# Central Planning Authority

**Minutes** of a meeting of the Central Planning Authority held on **November 23, 2022 at 10:00am in Conference Room 1038, 1st Floor, Government Administration Building, and Elgin Avenue.**

CPA/28/22

Current submission:

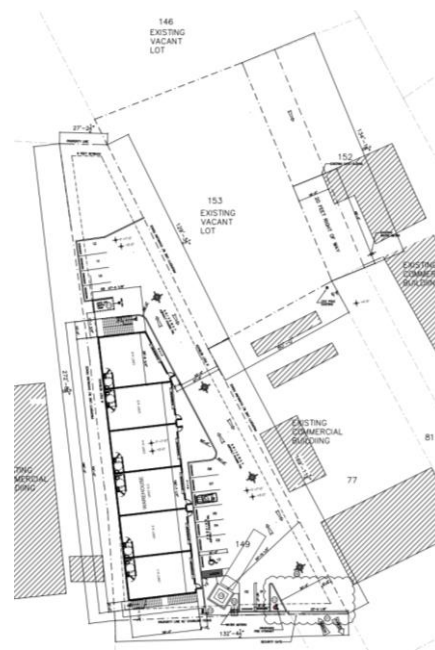
The Department acknowledges this is a minor issue and can be overcome by way of a condition seeking curbing of the driveway aisle, however, members attention is simply drawn to this.

Figure 1. The site of the proposed cement plant outlined in red (Source: LIS 2018)

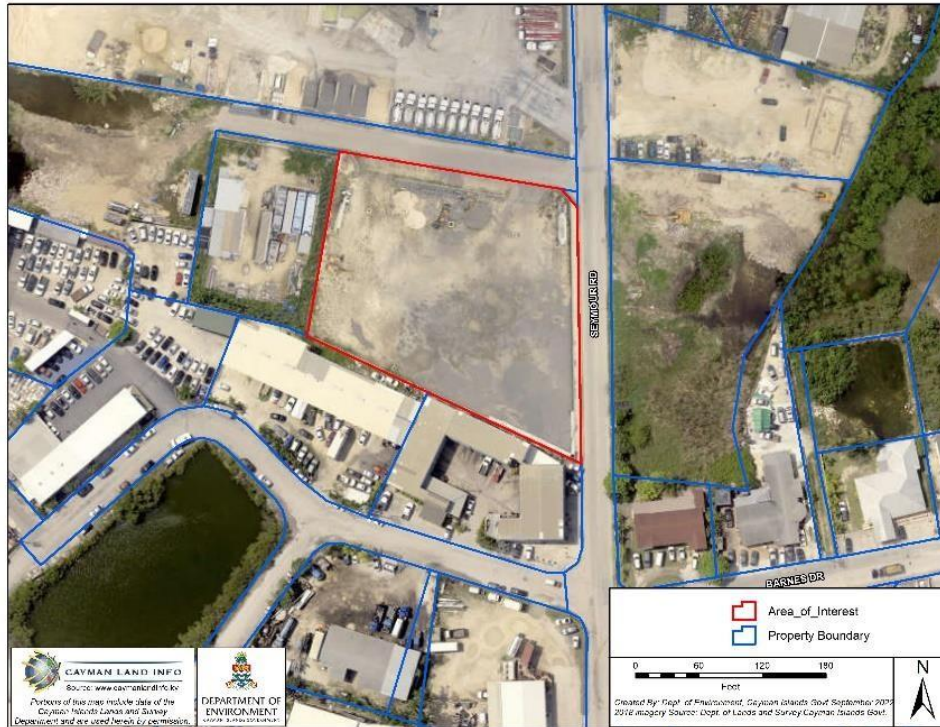
*The site plans do not appear to outline how residual concrete or cement slurry will be disposed of. It has been common practice to rinse the cement trucks and dispose of the residual concrete and slurry into remote areas including wetlands and/or potentially environmentally sensitive habitats. The practice of emptying waste or washing residual cement into areas not designated for such (including natural areas) should not be allowed. This practice can be discouraged and avoided by provision of appropriate facilities within a site boundary. The cement plant should be designed so that operators have a clear process for managing their wastes, for example by accommodating excess cement and cement residues. This should be included in an Operations and Maintenance Plan for the cement plant.*

Figure 1. The elevation drawings of one of the four cement silos, showing a proposed height of 97 feet.

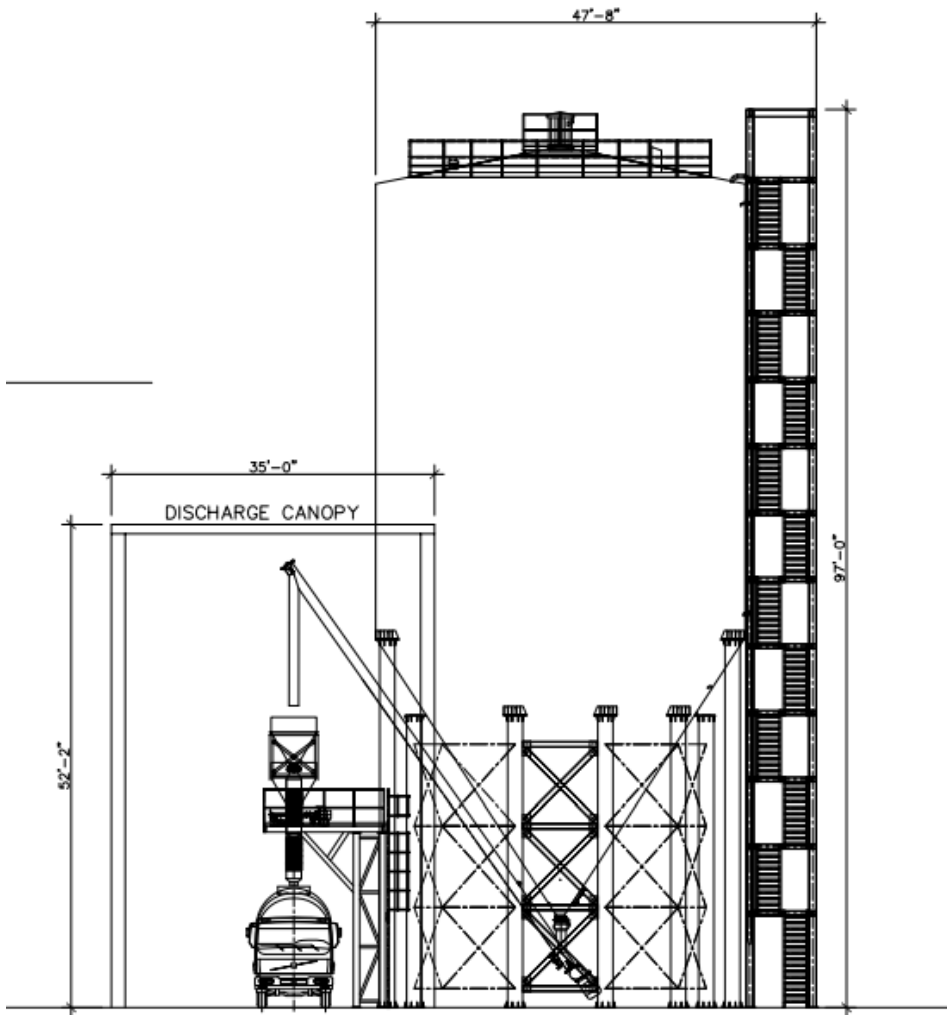
The Applicant has not provided any detail on how dust emissions will be controlled and whether there will be air quality monitoring and air pollution control equipment, or operational measures to prevent air pollution.
